UNITED STATES OF AMERICA
NUCLEAR REGULATORY COMMISSION

In the Matter of)
)
HYDRO RESOURCES, INC.)
2929 Coors Road, Suite 101)
Albuquerque, NM 87120)
)

Docket No. 40-8968-ML
ASLBP No. 95-706-01

WRITTEN TESTIMONY OF MICHAEL G. WALLACE

FIGURE 9
 POTENTIOMETRIC SURFACE
 END OF RESTORATION
 WELL FIELD # 2
 SUMMER GRADIENT

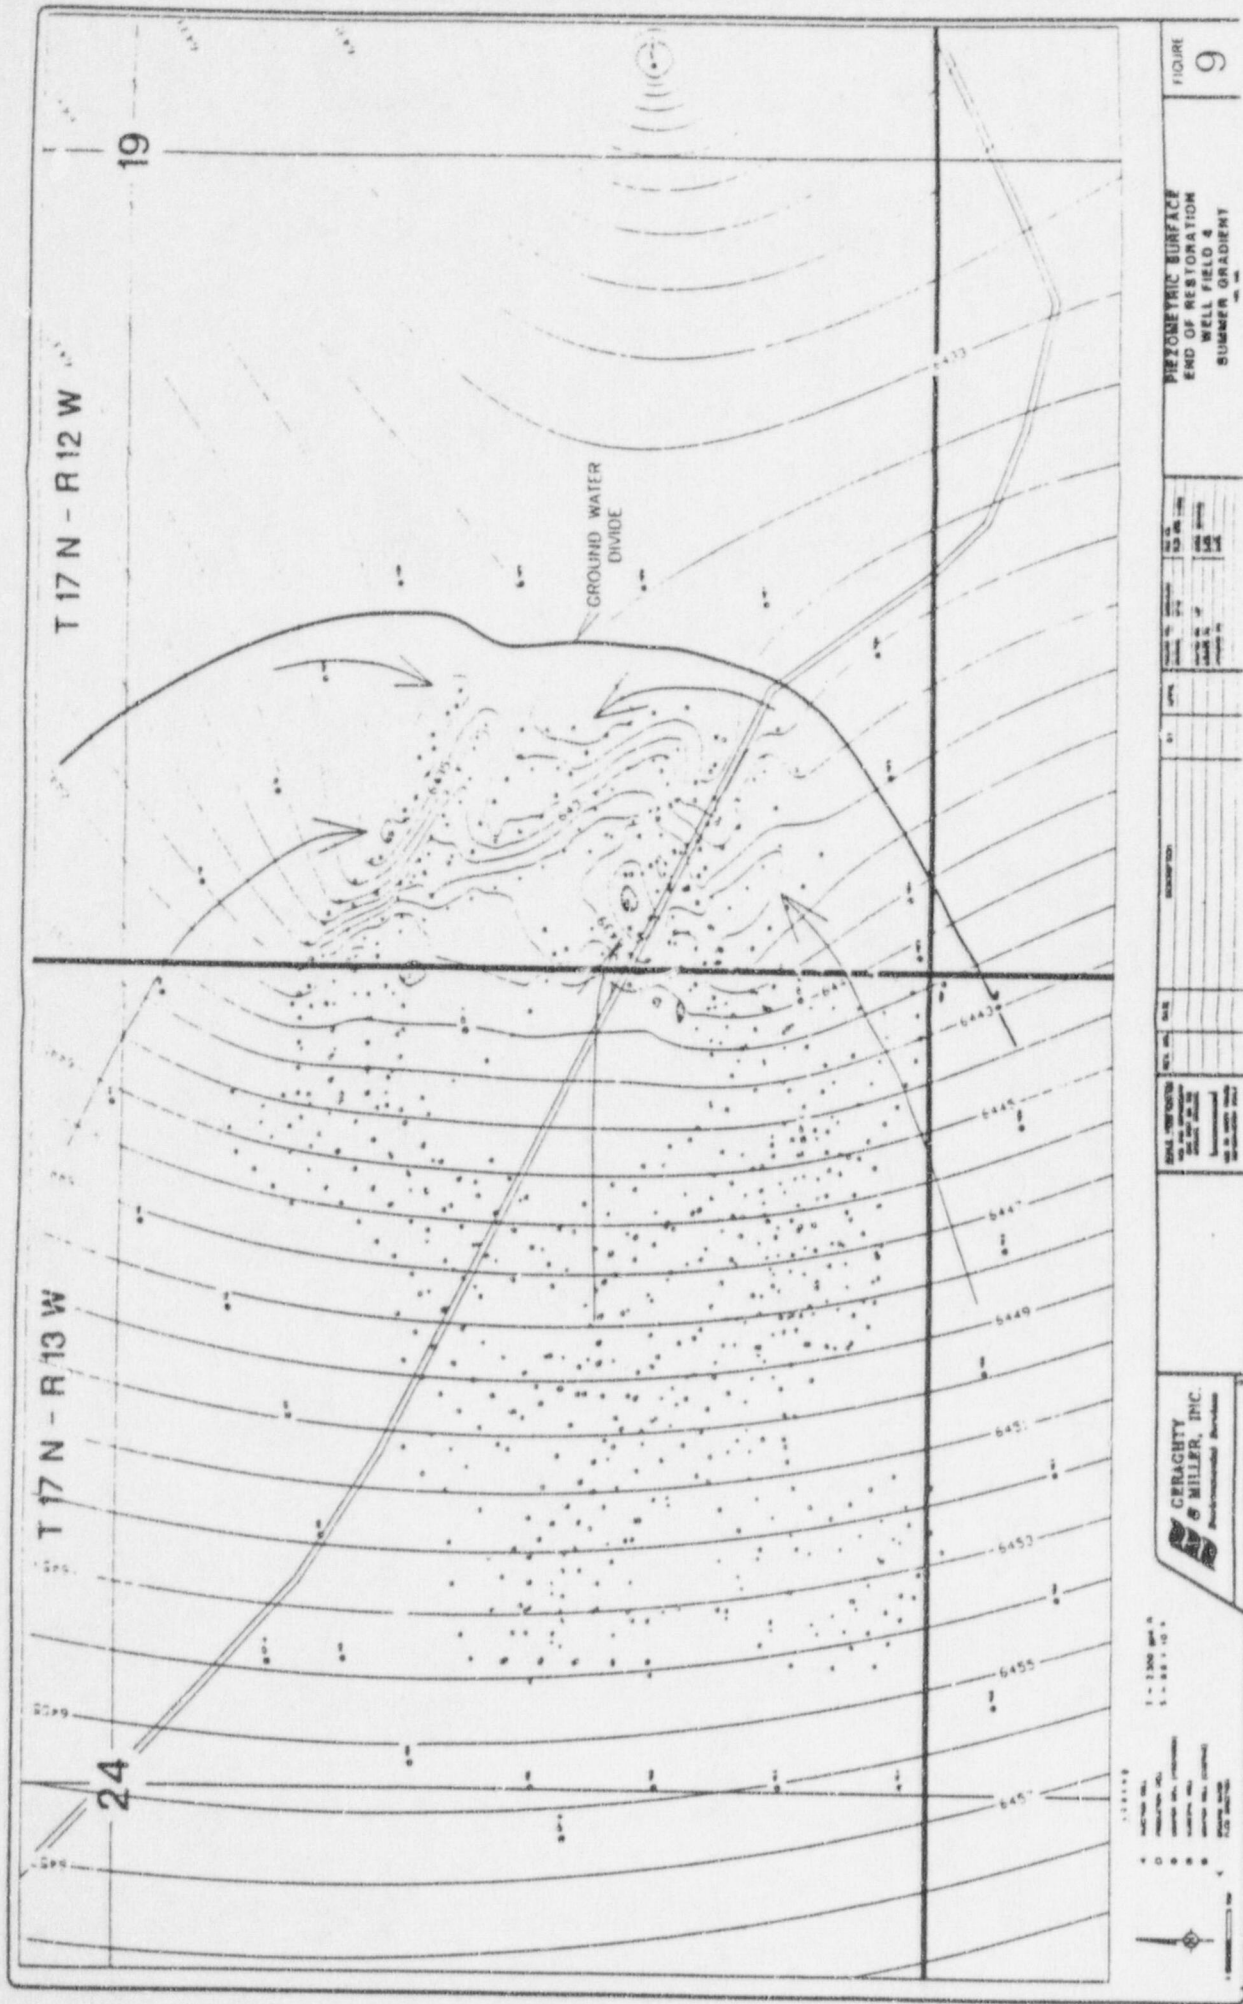
Another example is seen in Figure 9, where five pathlines are shown, all generally converging upon a central location. The arrow of the long pathline located at the lower center of the diagram is about to cross the same head contour (the 6439 value) twice. This, of course, violates Rule #2. Even of more concern is the next pathline to the right that roughly parallels the so-called groundwater divide line. Clearly, at its arrowhead, it

To illustrate the correct direction of water flow on Figure 9, I have drawn, by hand, my best estimate of the correct flow pathlines and groundwater divide lines; this revised Figure 9 is attached hereto as **Exhibit K**. My version of the diagram shows groundwater

FIGURE
10

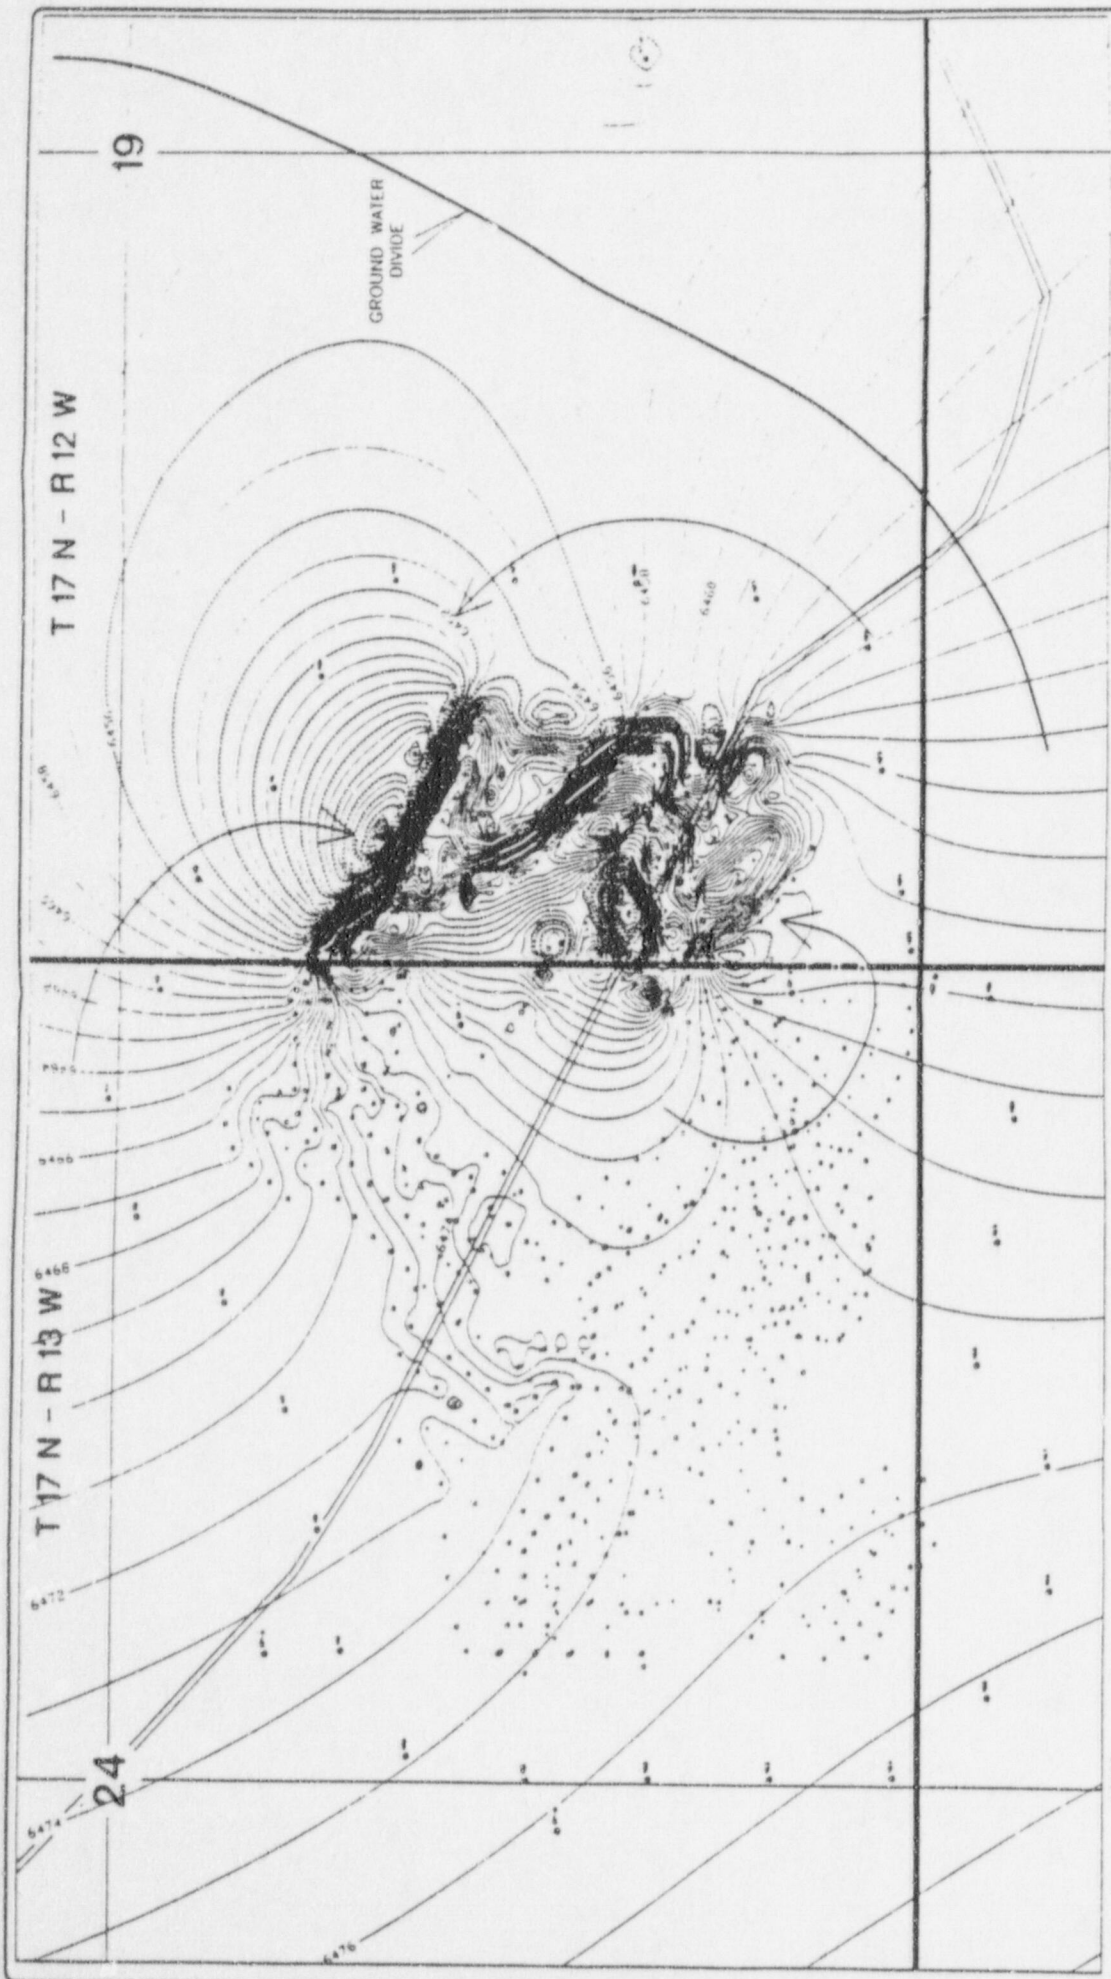
In examining the diagrams in the Geraghty and Miller report, I noticed that not all pathlines crossed head contours at right angles. For example, in Figure 10, the lower center pathline that forms a U shape crosses seven head contours, from left to right. Clearly, the sixth contour it crosses, just below its arrowhead, is not crossed at a 90 degree angle, thereby violating Rule #1. Had the pathline been drawn correctly, it would have indicated a significantly different trajectory. Many of these pathlines or others, if drawn correctly, would show fluid leaving the mine zone and escaping into the general aquifer. I can only conclude, as a professional in this field, that the pathlines were drawn in a manner that could mislead a reviewer into believing that containment of lixiviant is demonstrated, where in fact, it is not.

Figure 2. Plot of drawdown points for monitoring well CP-2 matched to Modified Hantush Curve.

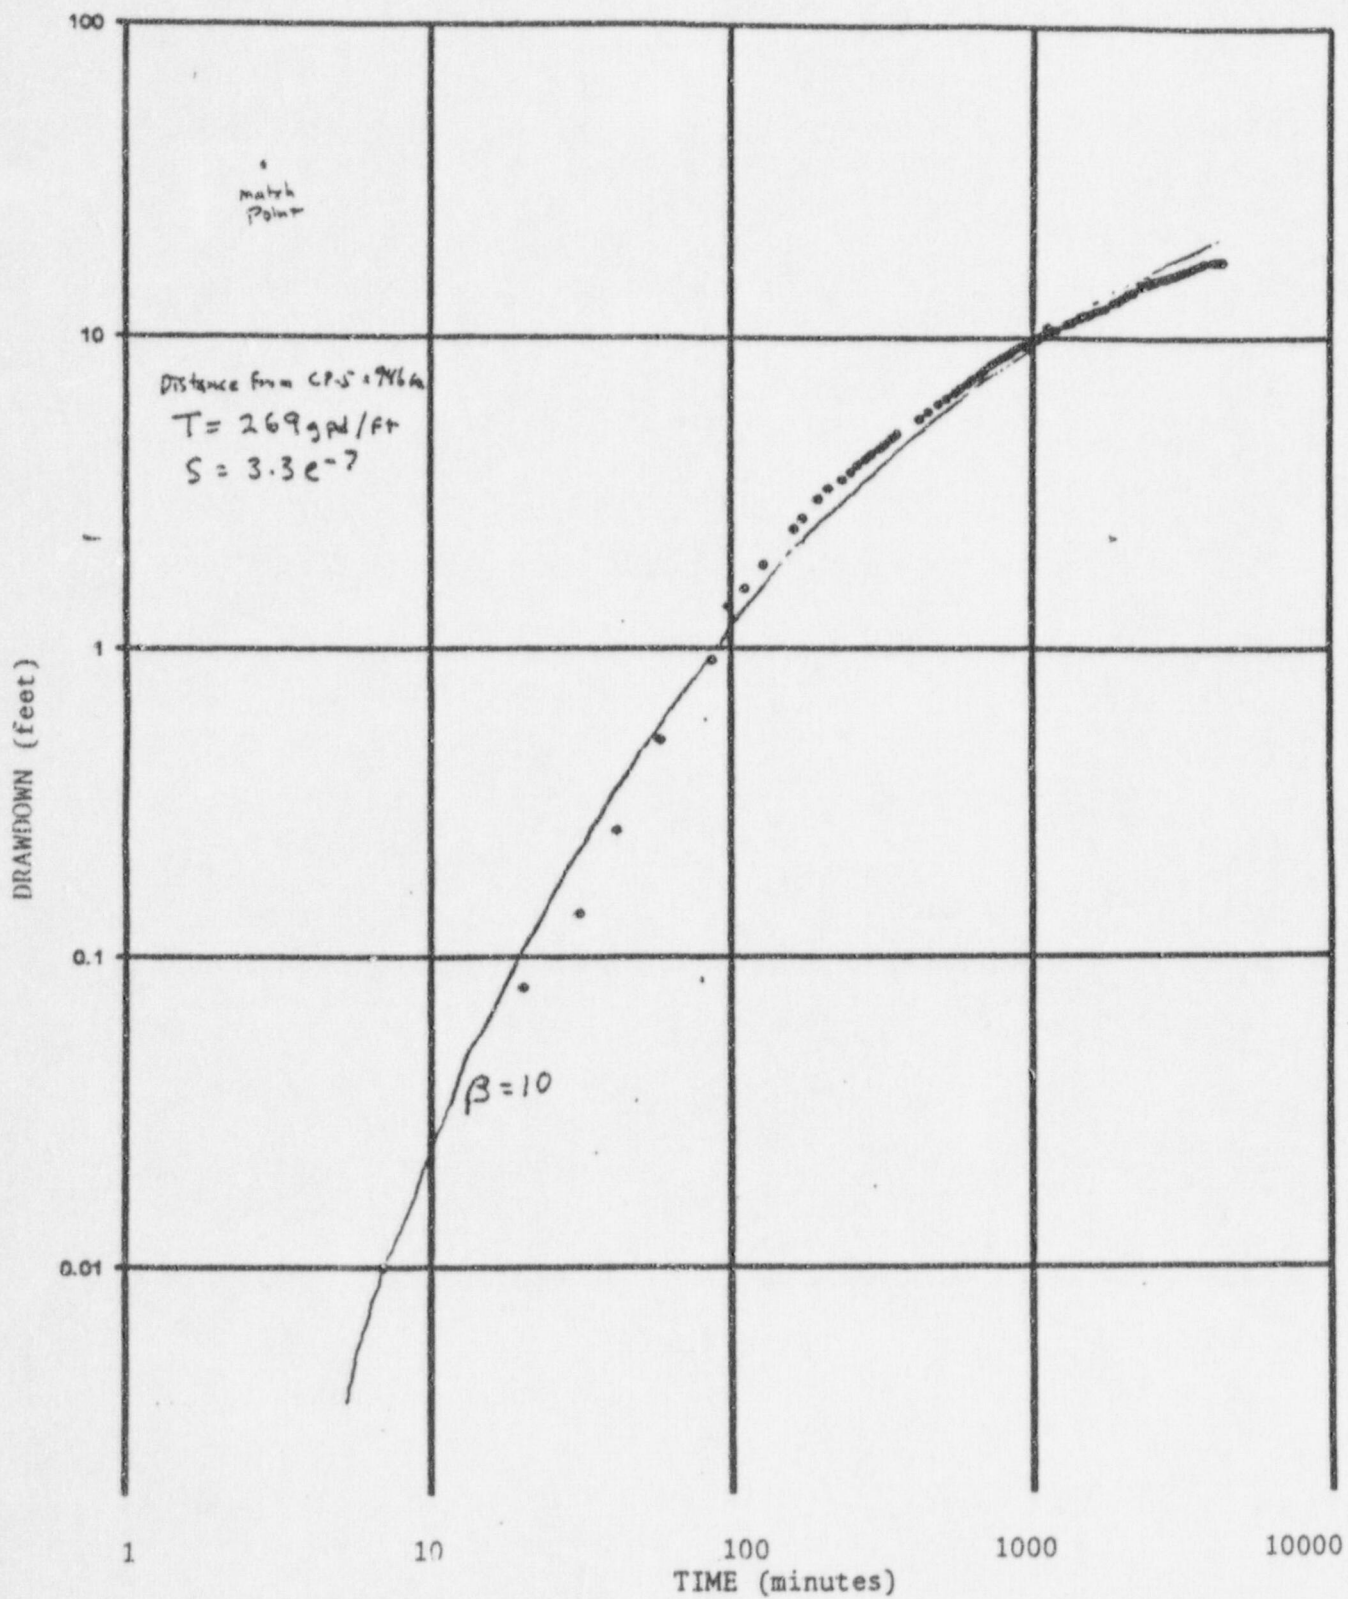
The results of my evaluation are shown in Figures 4 and 5, attached as **Exhibit M** to this testimony. These figures show a series of computer-generated dots plotted on logarithmic scales; the x-axis shows time elapsed (in minutes) since the beginning of the pump test and the y-axis shows water-level drawdown (in feet) for each point in time. For both plots, I overlaid the graphs on a series of Hantush-derived drawdown "type curves" published by the U.S. Geological Survey (Lohman, 1979, Plate 4). These curves represent the base case of zero leakage. Employing the prescribed methodology, and starting with the Theis-type curve, I moved the plots for each well across each successive curve until I found the curve that best "fit," or matched, the dots on my graphs. Neither of my plots matched the Theis-type, zero-leakage curve. For the plot for well CP-2, the best match was the curve representing $B = 10$; for the plot for well CP-3, the best match, especially for the point earliest in the test, was the curve representing $B = 0.7$.¹³ These
